FIRST ENDORSEMENT on CO, 2d MaintBn ltr 11000 4/N/R of 2 Aug 1985

Subj: INFORMATION CONCERNING PROJECT P-257

Subj: PLANNING INFORMATION FOR NEW IMA INSPECTION STATION
(P-257)

OVERLAY FOR
 PROPOSED INSPECTION STATION
 NAVFAC 1294508

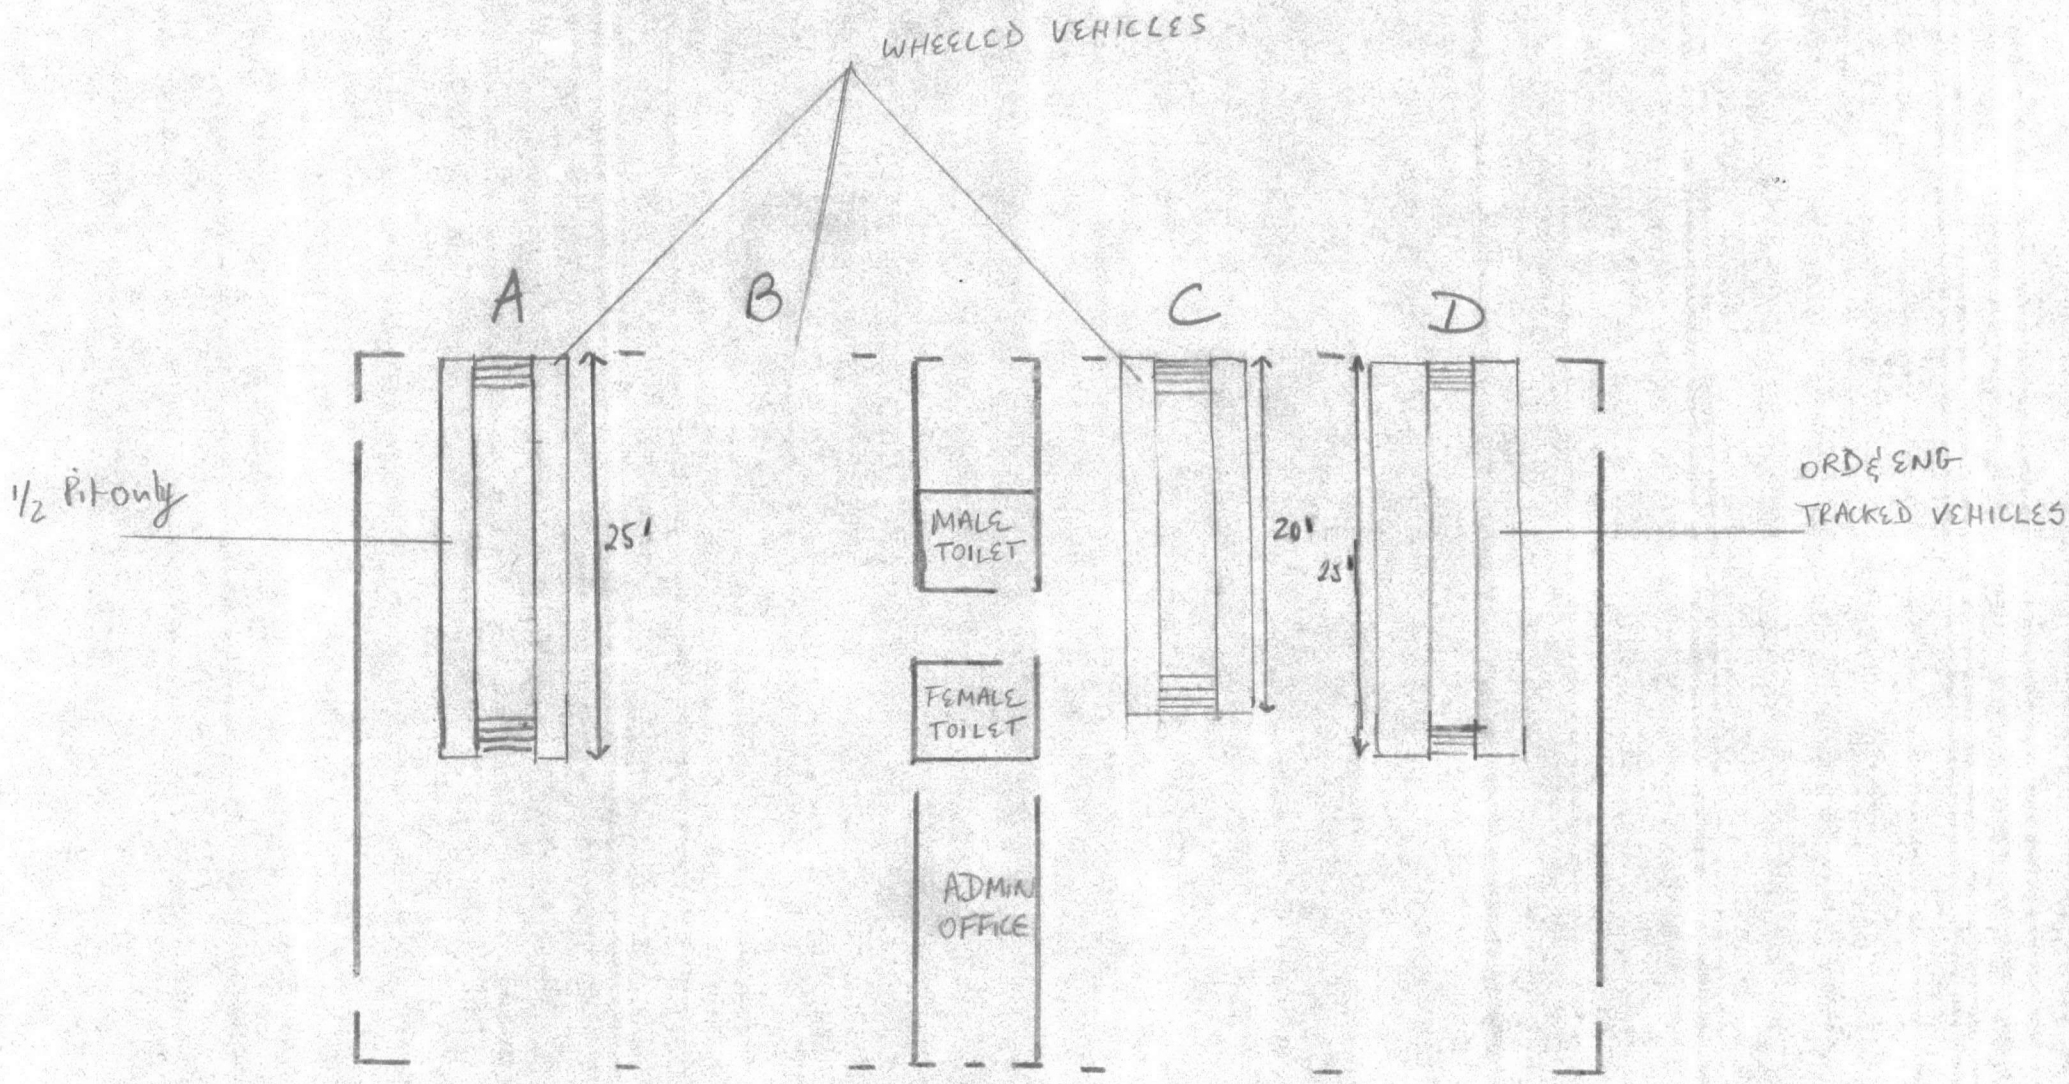
a. Stalls A and C should be designed (both width and height) to accommodate the complete range of vehicles listed in enclosure (1). We recommend the pits be forty inches wide. Pit A should be twenty-five feet long. Pit C should be twenty feet long.

b. Stall D should be designed (both width and height) to accommodate the range of vehicles listed in enclosure (2). We recommend the pit be fifty inches wide and twenty-five feet long.

3. Enclosure (3) provides an overlay depicting our proposed layout recommendations. In addition, we identified the following design requirements:

a. No lifts will be needed. The availability of three pits as noted, would satisfy our requirements. The pits should be equipped with the following:
